Historical Release Report *(Interim Update)*

Response to Comments
for
HRR Annual Updates (1997, 1998, 1999)

**Response to Comments and Meeting Agreements
for the
Historical Release Report (HRR)
PAC Narratives Submitted for No Further Action in 1997, 1998 and 1999**

August 3, 2000

FIGURE 3-5
OU8-IHSS 123.1
SURFACE-SOIL ANALYTICAL
RESULTS FOR ORGANICS

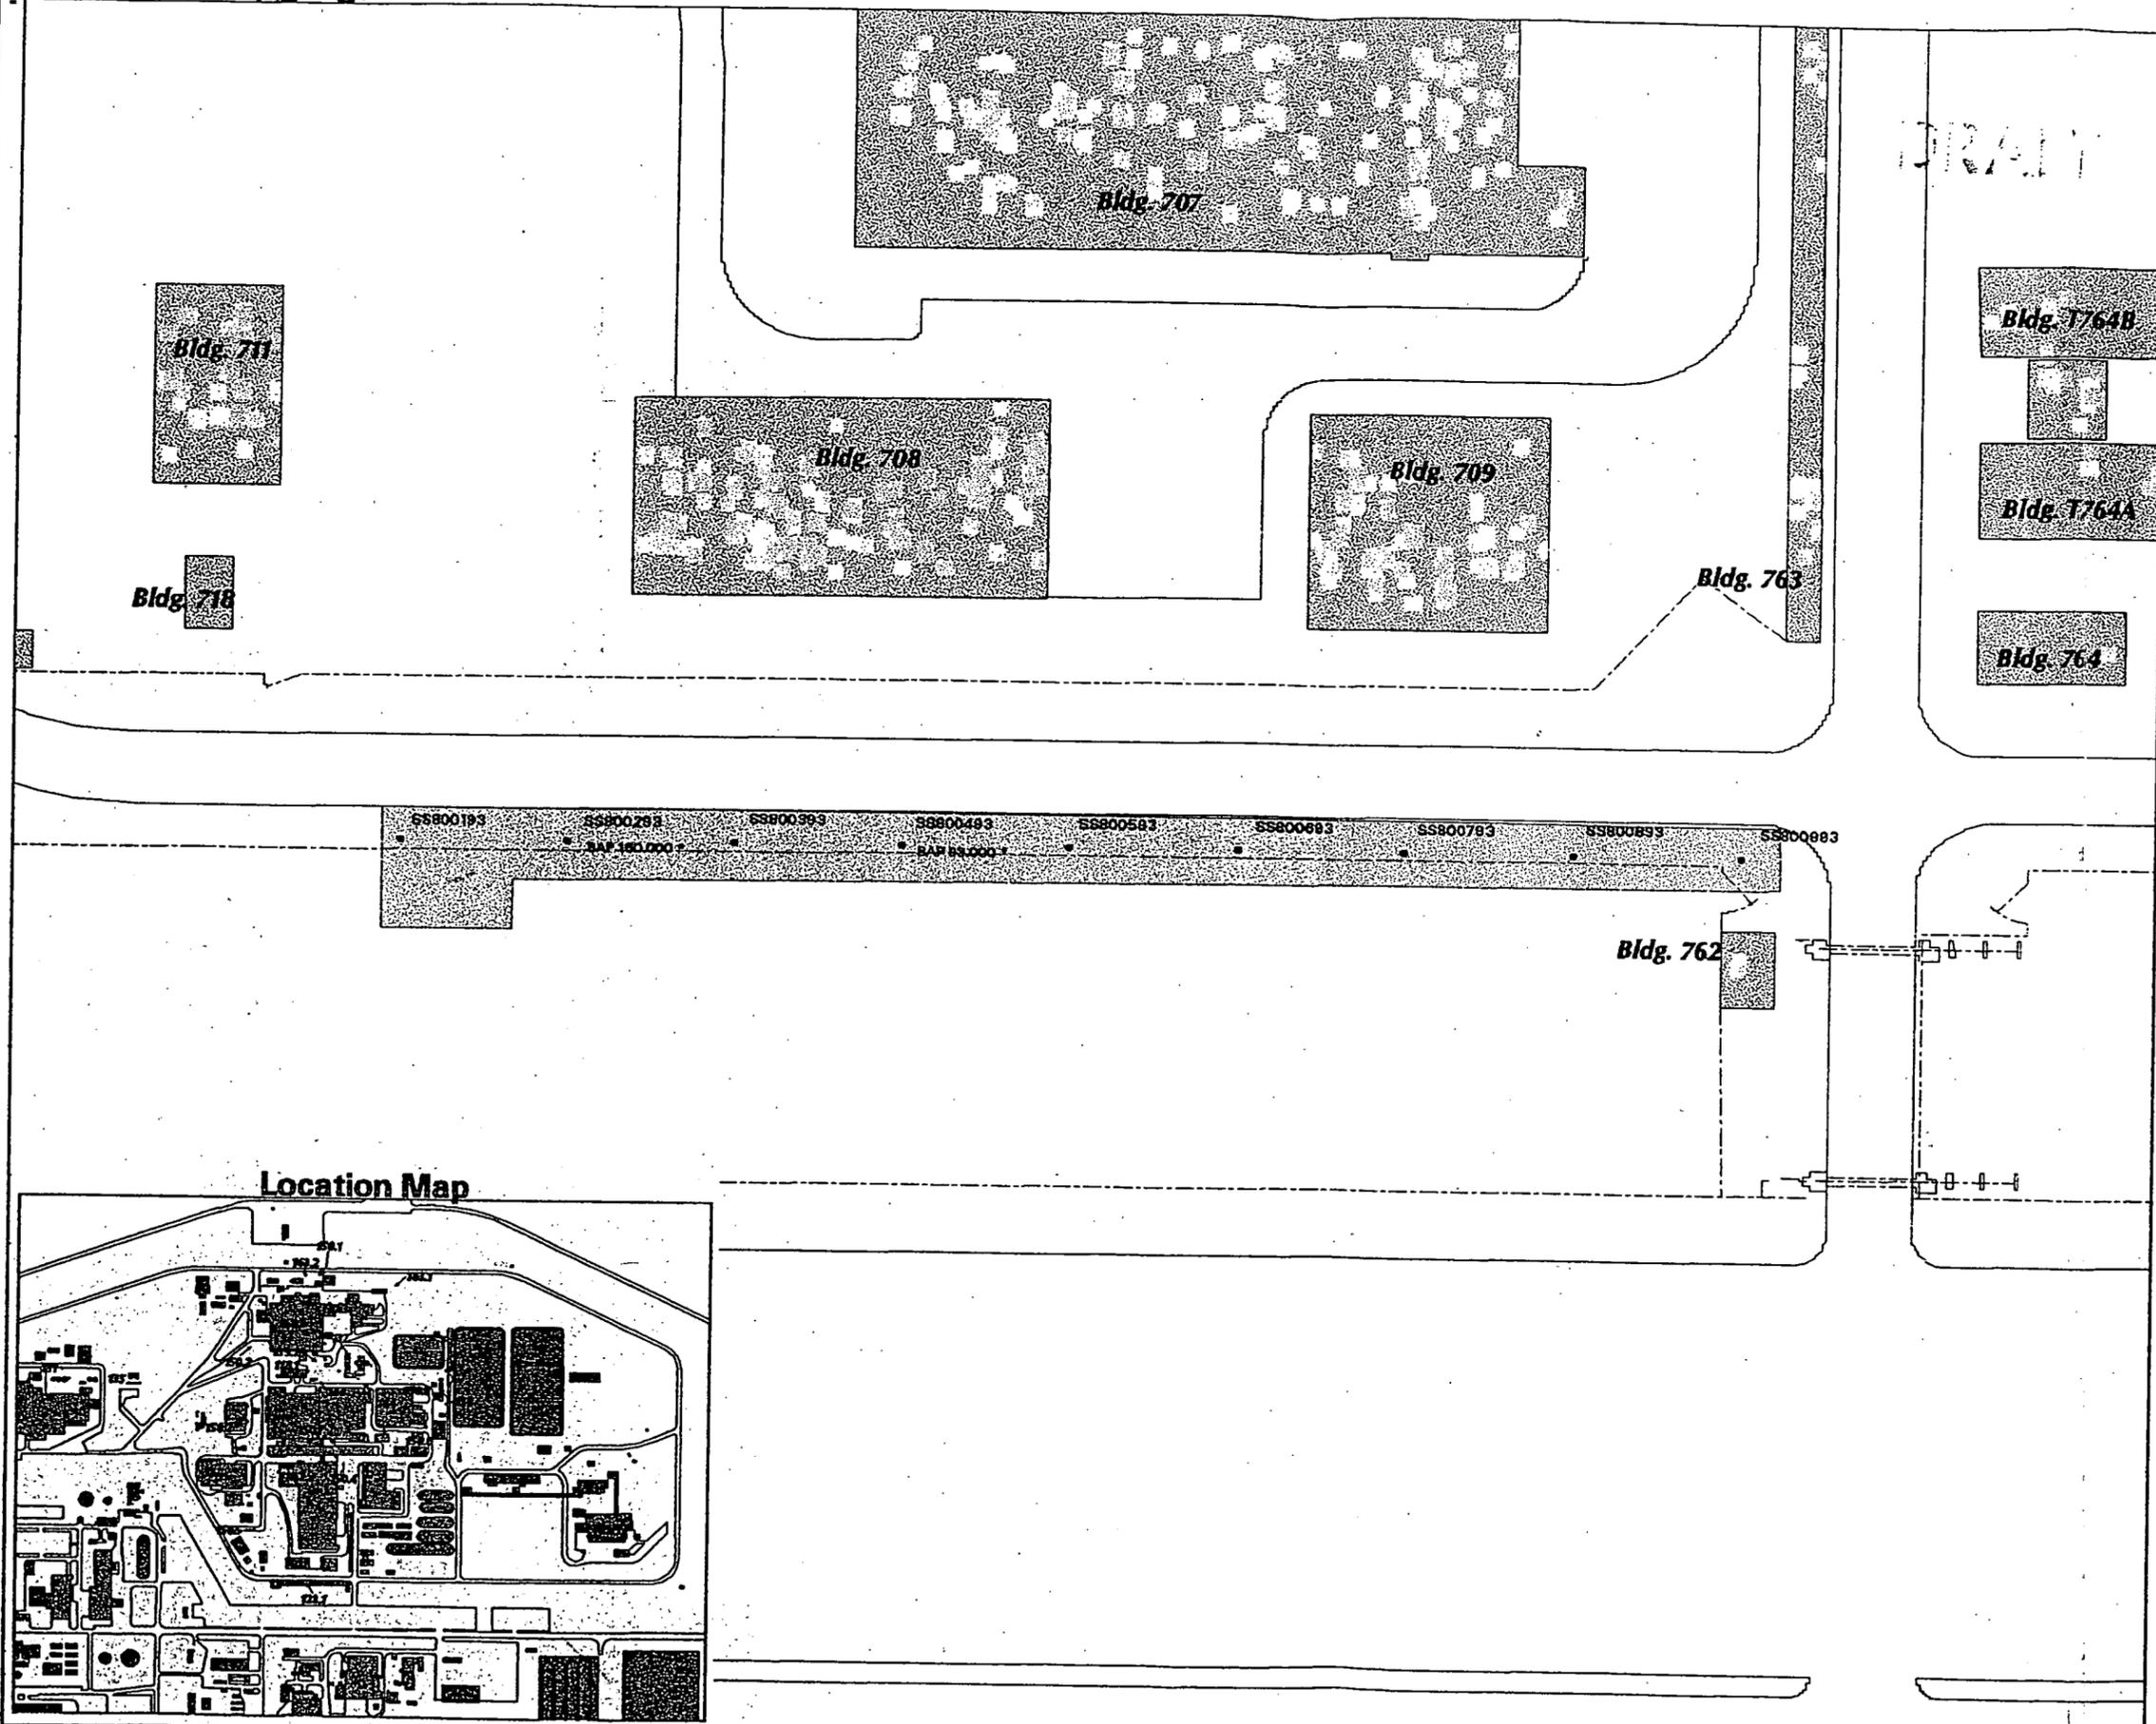
IHSS 123.1 (PAC 700-123.1) was studied in accordance with the IAG schedule for Operable Unit 8. As documented in the Operable Unit 8 Data Summary Report (DOE, 1995), IHSS 123.1 was sampled at nine locations (see Figure 3-4 & 3-5) for inorganics, radionuclides, volatile organic compounds, and semi-volatile organic compounds. These data were validated, compared to background concentrations (if applicable), and then compared to soil actions levels presented in Attachment 5 of RFCA. There were no detections with the exception of benzo(a)pyrene which was present in the sample but below the MDL (Table 1-1).

During the 1995 study for IHSS 123.1, all analytical data were collected in accordance with an approved workplan. Currently, all analysis are below RFCA Tier II action levels (DOE, 1996) and at or below established background levels for radionuclides. Sampling methodology for IHSS 123.1 was consistent with current Sampling and Analysis Plans (SAPs) and no current source of contamination could be identified. Therefore, IHSS 123.1 is proposed for No Further Action based upon comparison of the analytical data to current RFCA action levels.
